FAQ 21-01: Unplanned Scrams with Complications for AP1000
Tentatively Approved

Plant: Generic to AP1000 Reactors

Performance Indicator: IE04, Unplanned Scrams with Complications (USwC)

5. Conforming changes are needed in the depiction of PWR scram screening questions in Figure 2, as follows:

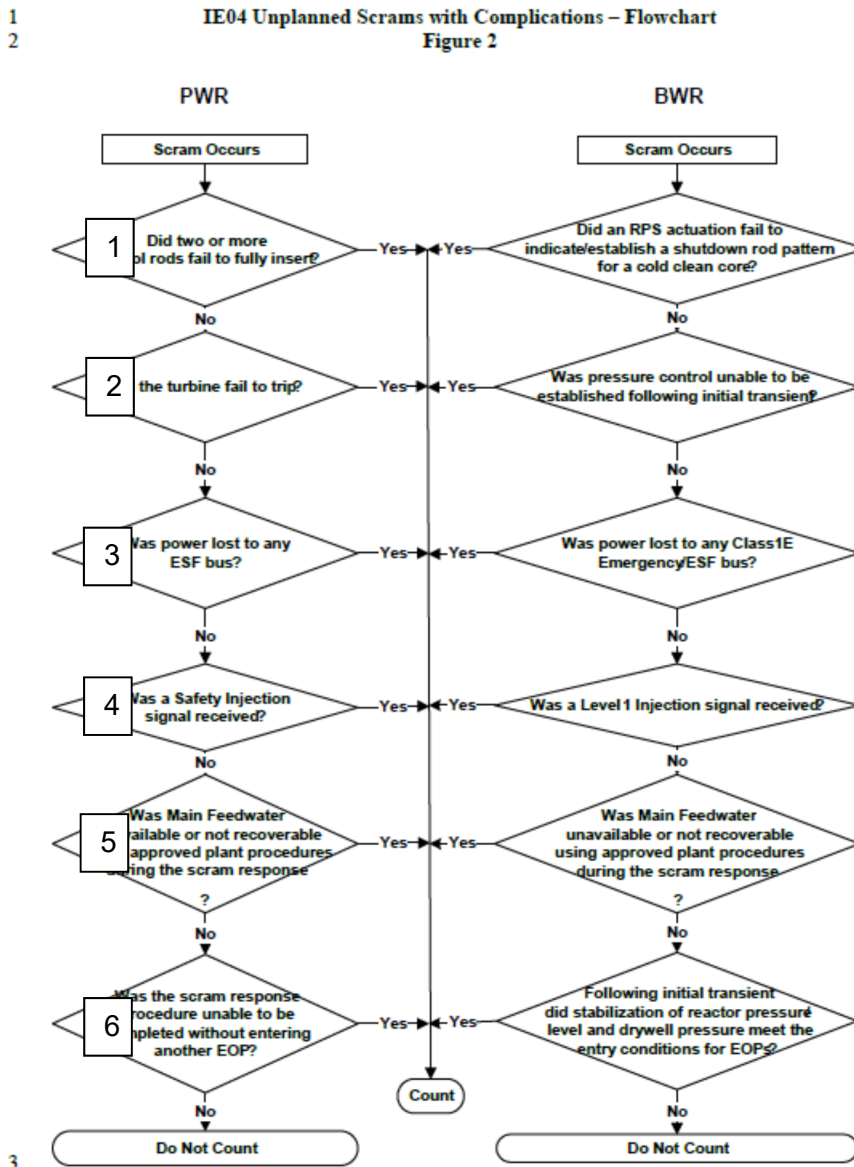
- a) For the third decision diamond, which reads, “Was power lost to any ESF bus?”, add the following footnote: “For AP1000: Was power lost to any battery backed Class 1E DC and UPS System (IDS) bus?”
- b) For the fourth decision diamond, which reads “Was a Safety Injection signal received?”, add the following footnote: “For AP1000: Was a Safeguards Actuation signal received?”
